Display

Model: **BVM-1311/1316/1316C/1911/1912**
BVM-1915/1916/2811

Subject: **BOUNCED BRIGHTNESS WHEN 100IRE FULL-WHITE SIGNAL IS SWITCHED TO 20IRE**

Figure 1

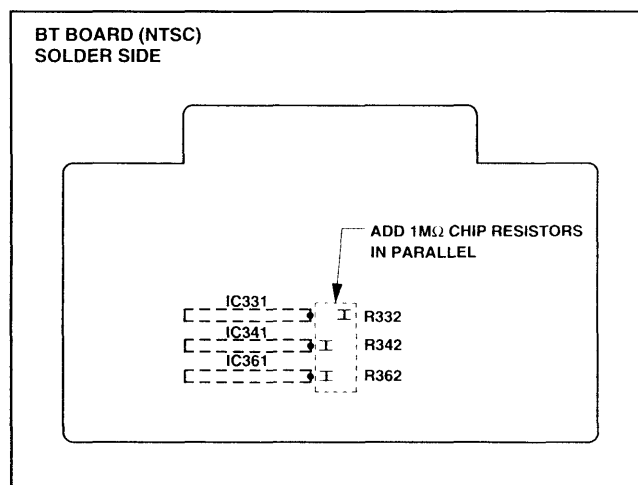
If brightness is bounced when a 100IRE full-white signal is switched to 20IRE, perform **one** of the following modifications, for either NTSC **or** PAL models.

BT Board (Solder Side)
See Figures 1 and 2.

1. Remove the shield case from the BT board.
2. Install one 1MΩ chip resistor in parallel, on top of each of the following three resistors:
 - R332
 - R342
 - R362

Figure 2

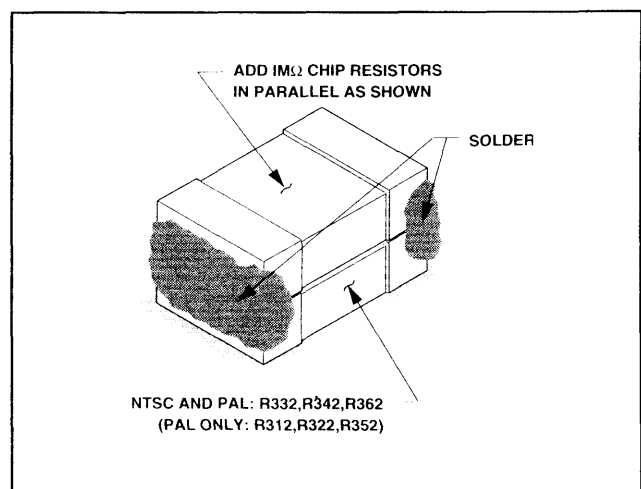
BT Board (Solder Side)
See Figures 2 and 3.

1. Remove the shield case from the BT board.
2. Install one 1MΩ chip resistor in parallel, on top of each of the following six resistors:
 - R312
 - R322
 - R332
 - R342
 - R352
 - R362
